# Access Compliance Report

## Public Rights-of-Way

| Intersection ID: 13736                  | Main Street: CAMDEN_RD | Cross Street: N/A                       | Location: SE           |
| ADA ID: 732744F42F9D                    | Ramp Type: BlendTrans2 | Initial Pass/Fail: Fail                 | Overall Compliance: No |

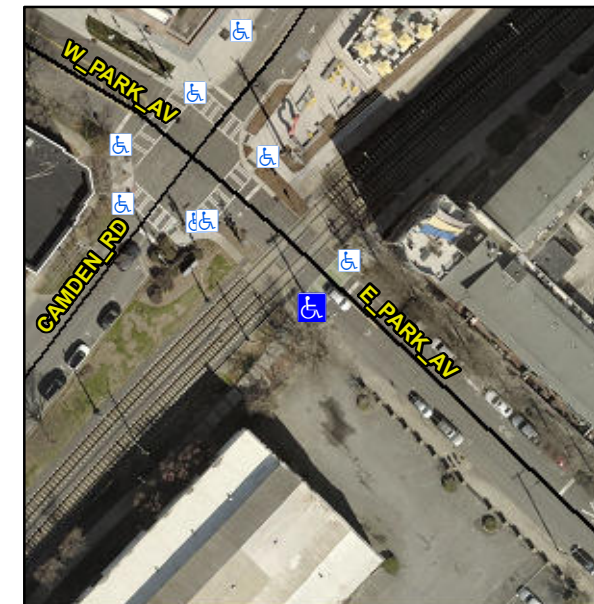
**Not Found, R304.5.3**

| Compliance | Description           | Data  | Compliance | Description                 | Data |
|------------|-----------------------|-------|------------|-----------------------------|------|
| Yes        | Ramp Width (in)       | 120.0 | No         | BlendTrans XSlope (%)       | 3.6  |
|            |                       |       | No         | Curb Slope (%)              | 6.4  |

**Remove & Replace Curb Ramp With Two New Directional Ramps or Equivalent.**
